ADDENDUM NO. 01

Issued: November 20, 2018

Project: Valley Park Elementary School Addition
12301 Lamar Avenue, Leawood, Kansas 66209

Project No. 18027
BVSD Project No. VPE-1901

S1 SHEET S101A –FOUNDATION PLAN – AREA A – LEVEL 1

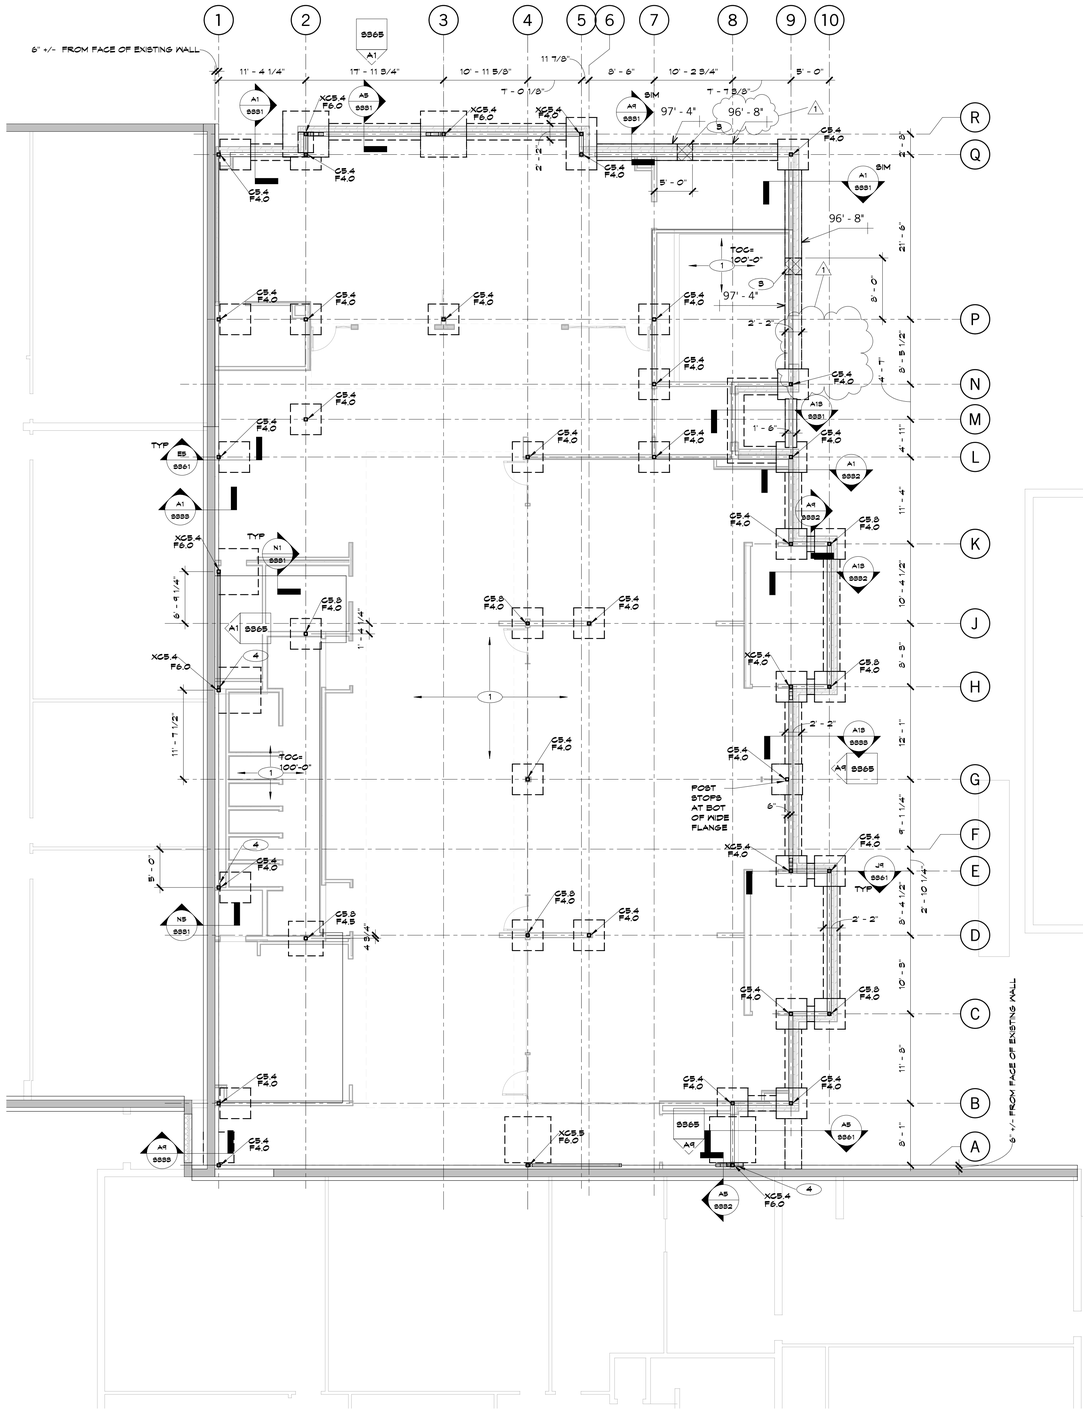
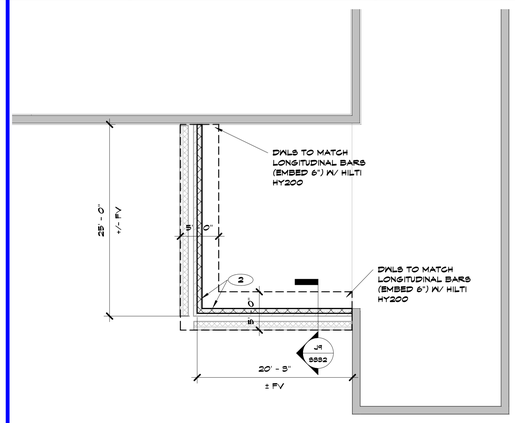
S1.1 REVISE portion of Sheet S101A, according to changes indicated, dated November 20, 2018, attached.
